Technical Service Bulletin

Subject: 05-001/17 GRINDING NOISE FROM MANUAL TRANSMISSION IN 2ND AND/OR 3RD GEAR AND/OR HARD TO SHIFT INTO 2ND AND/OR 3RD GEAR	Bulletin No.: 05-001/17
	Last Issued: 06/08/2017

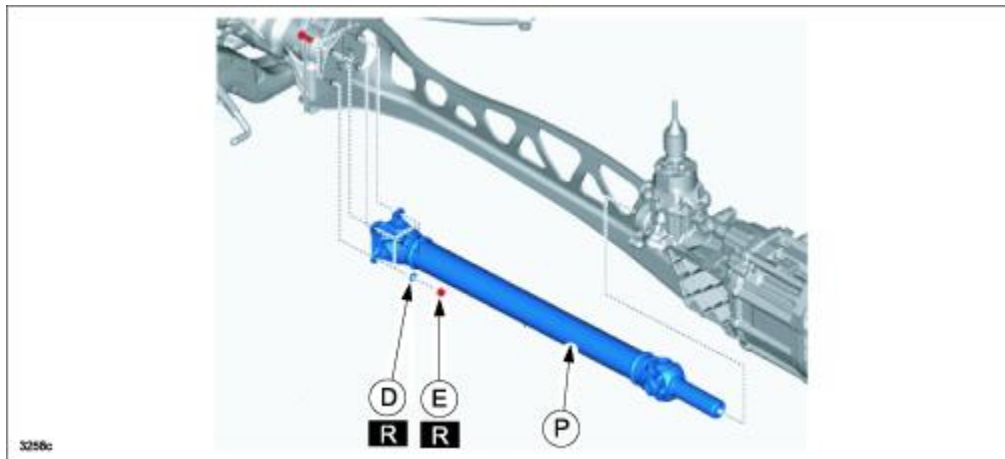
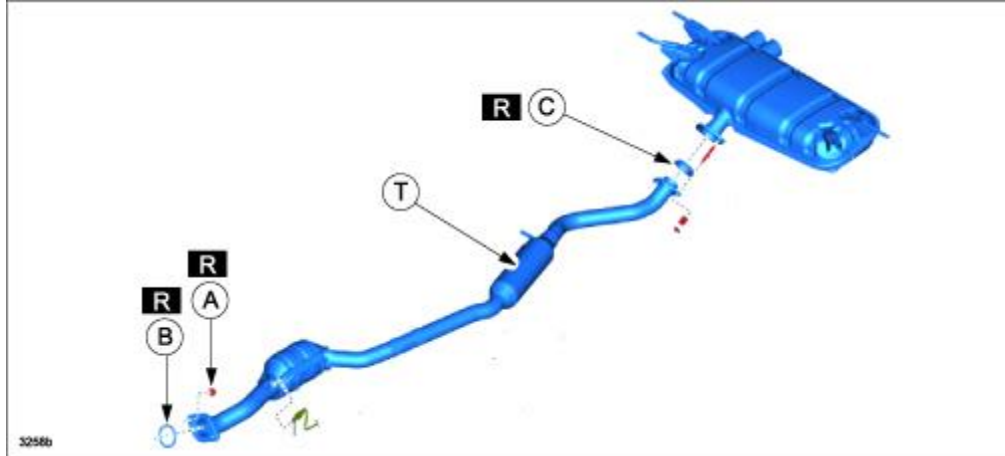
This may be caused by damage to 2nd and/or 3rd gears if the vehicle was driven with rapid acceleration and deceleration using frequent shift changes. To eliminate this concern, the configuration of the 2nd and 3rd gears has been changed to increase the rigidity.

NOTE: Transmissions with the serial No. "6TJ0701679" or higher are modified.

1. Verify the customer concern.
2. Replace the complete manual transmission with a modified one according to the instructions on MS3 (TRANSMISSION REMOVAL/INSTALLATION [M66M-D]).
3. Verify the repair.

Replacement Parts Location

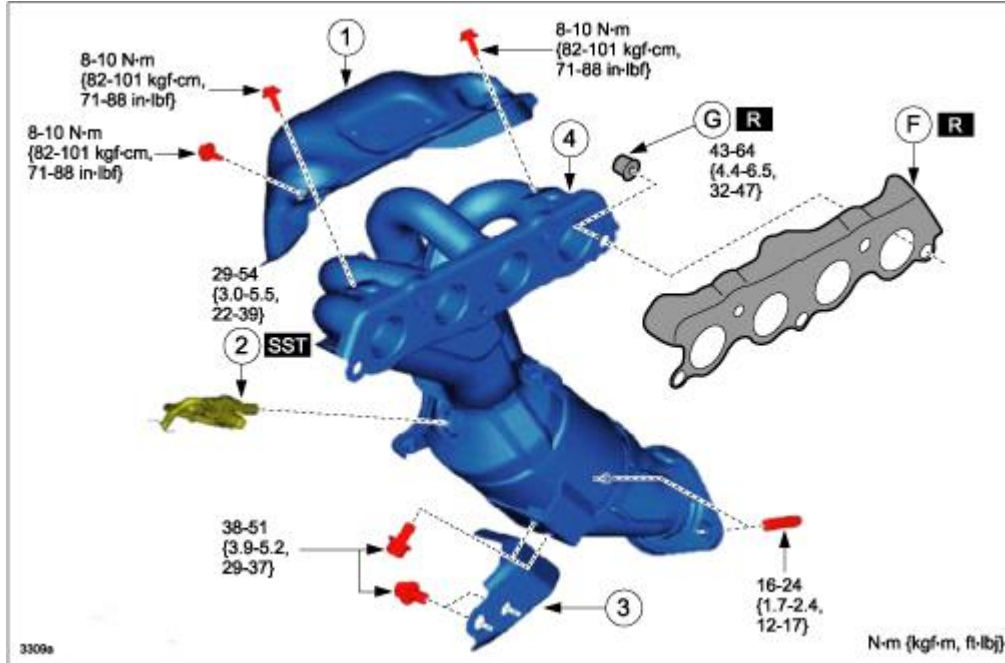
Parts Number	Description	Qty.	Notes
M602-03-000	Manual Transmission Complete	1	Manual transmission replacement requires MASH authorization.
9994-61-000	Nut, TWC (T)	2	A
PE23-40-305	Nut, TWC (T)	1	B
RFK2-40-581	Seal Ring, TWC (T)	1	C
1368-25-124	Nut, Propeller Shaft (P)	4	D
9997-11-000	Spring Washer, Propeller Shaft (P)	4	E
PEJ5-13-460	Gasket, Exhaust Manifold (2.0L)	1	F
PYB1-01-006	Nut, Exhaust Manifold	5	G
